COUNCIL ASSESSMENT REPORT

Panel Reference	PPSSNH-642
MOD Number	MOD2025/0030
LGA	City of Ryde
Proposed Development	Modification to Land and Environment Court Consent 2021/216311 (LDA2020/0199) to amend the approved mixed used use development by amending the landscaping, minor façade changes and amend Condition 133 in regard to the laundry facilities for the Boarding House rooms.
Street Address	1 to 20 Railway Road & 50 Constitution Road Meadowbank. <ul style="list-style-type: none"> • Lots 1 to 8 of DP 13637; • Lots 4 and 5 of DP 7533; • SP 35053; • Lots 1 and 2 of DP 384872; and • Lots 9, 10 and 11 of DP 7533.
Applicant	Juey Thanyakittikul, The Trustee for Apt Hold Trust 1
Owner	The Trustee for Apt Hold Trust 1
Date of DA lodgement	23 April 2025
Total number of unique submissions	Nil
Recommendation	Approval
Regionally Significant Development (Schedule 6 of the SEPP (Planning Systems) 2021)	A Section 4.56 modification application to a development with a capital investment value of more than \$30 million.

Figure 4: Comparison of the approved façade of Building C and proposed change in material. The proposed minor changes will not significantly alter the finished look of the building.

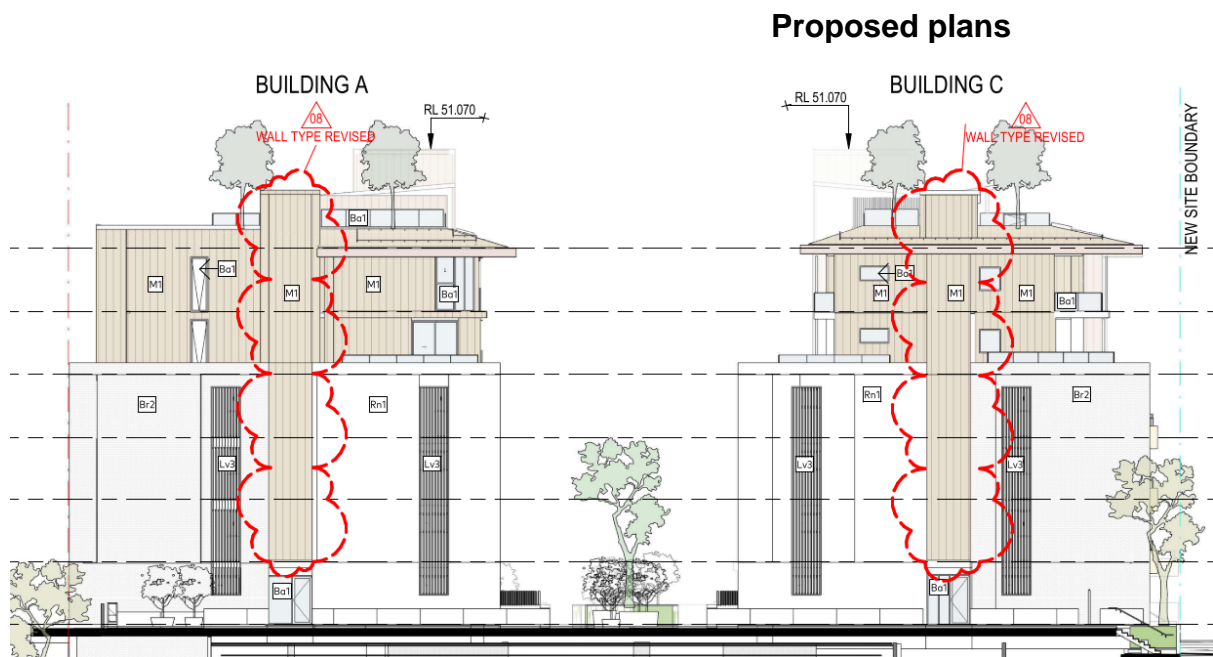
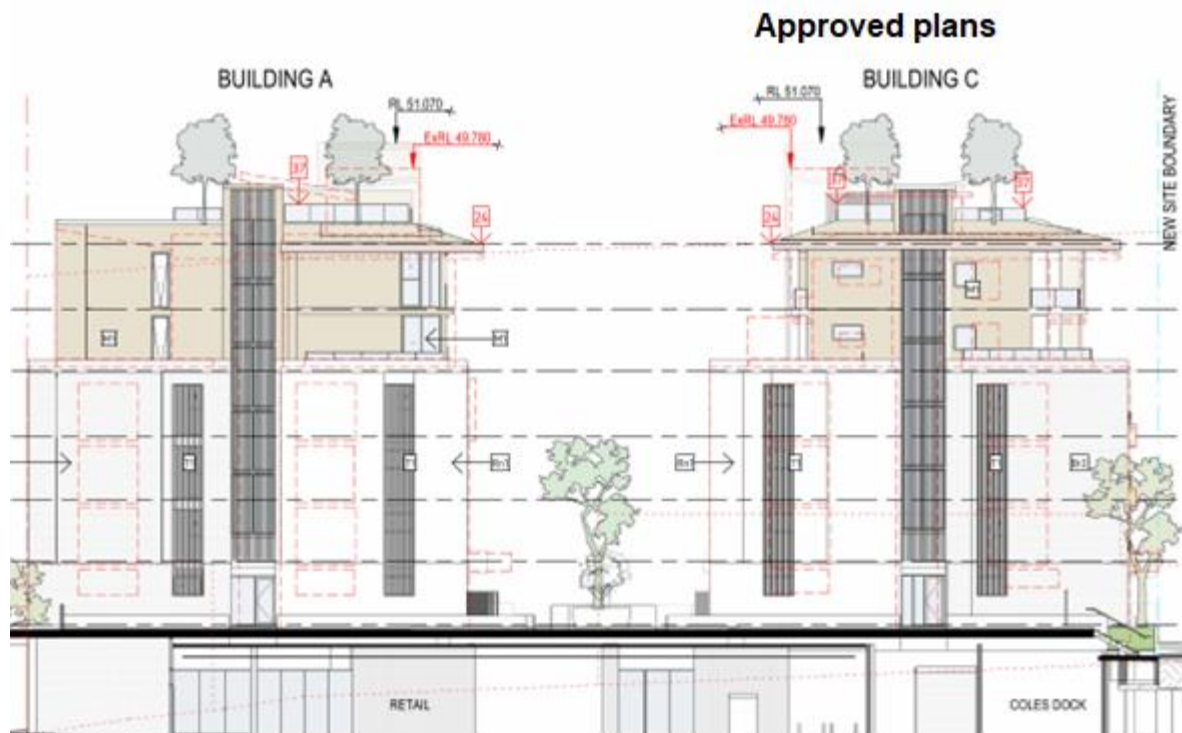
Whilst there are no changes to the internal amenities of the residential flat buildings, it is proposed to do some minor changes to the facades of the buildings with changes in materiality. The changes do not alter the built forms, bulk or scale.

Figure 5: Comparison of approved plans to change material from timber aluminium cladding to raised/receded metal cladding with change of wall type for the stair wells.

Figure 6: Comparison of the approved plan and proposed modification for the south west elevation of Building D (Boarding House) – elevation faces Underdale Lane with a building separation of 20.8m from the building opposite. Sufficient building separation to protect the amenity of each buildings.

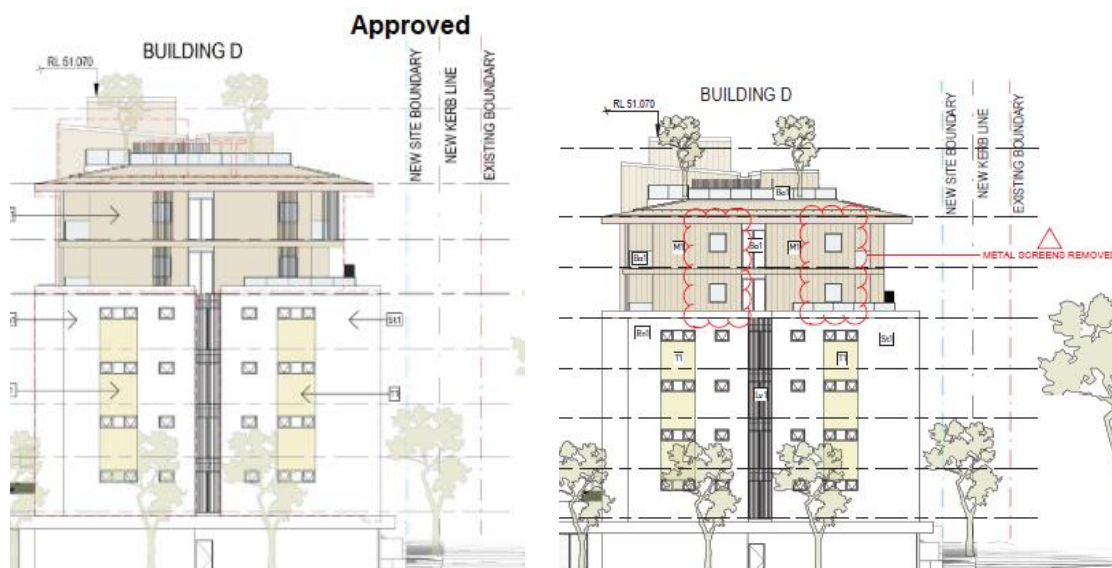
It is noted that plan DA3107 show the south west facing windows of Building D (Boarding House), the metal screen screens on Levels 5 & 6 removed from the setback windows.

Figure 7: Plan and elevation showing typical boarding room with a tub, washer/dryer and storage area.

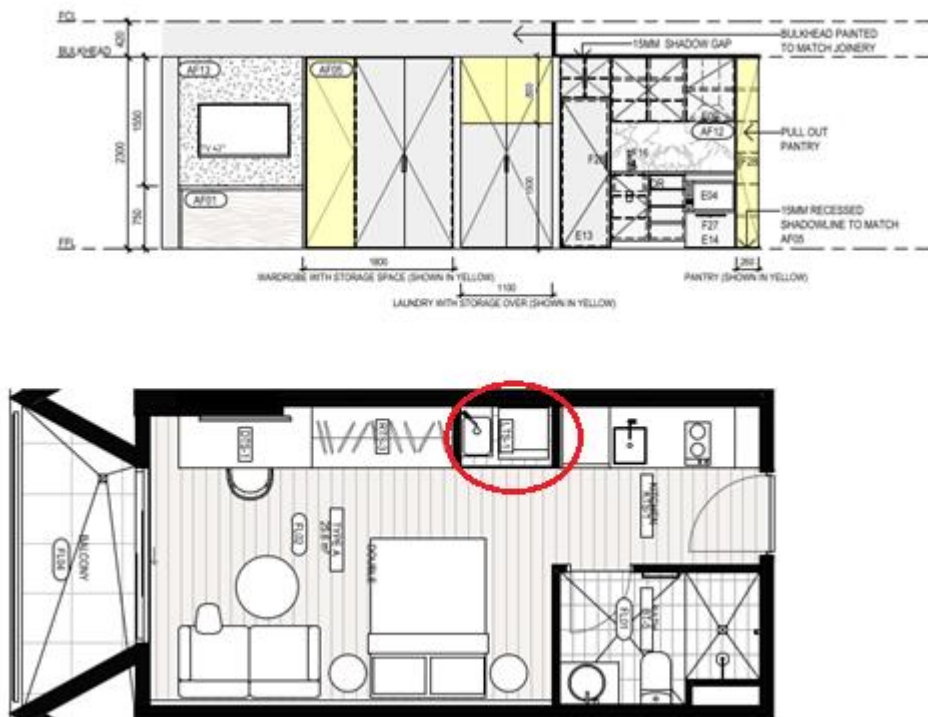
The proposal showed a wash tub and washer/dryer in each "typical" room with wardrobe /storage space provided, as shown in the **Figure 7** below.

The applicant now seeks to amend the condition to delete the “1.1m², wash tub and star rating of no less than one star below the maximum star rating available” requirement.

“The proposed amendments to Condition 133 is sought because the laundry cupboards, as approved, have been sized to fit the required clothes washing facilities. For typical studios these are approximately 0.96m². Further increasing this area would create an unusable space beside the washing/dryer machine and reduces available storage in the kitchen and wardrobe. Laundry facilities in the accessible studios are integrated into the kitchen cabinetry to comply with wheelchair circulation space requirements.

It would appear that the approved laundry cupboards in the “typical” boarding rooms are designed with 1.1m clear internal width to accommodate the tub (380mm) and washer/dryer (600mm). This provides a sufficient laundry area, with storage above. Therefore, increasing it at the expense of kitchen and wardrobe is not considered necessary.

The accessible rooms (12 out of 162 rooms) wash tub is integrated with the kitchen tub which is adjacent to the washer/dryer. Given this is for wheelchair accessibility purposes and is only for a very small number of rooms, the variation can be supported.
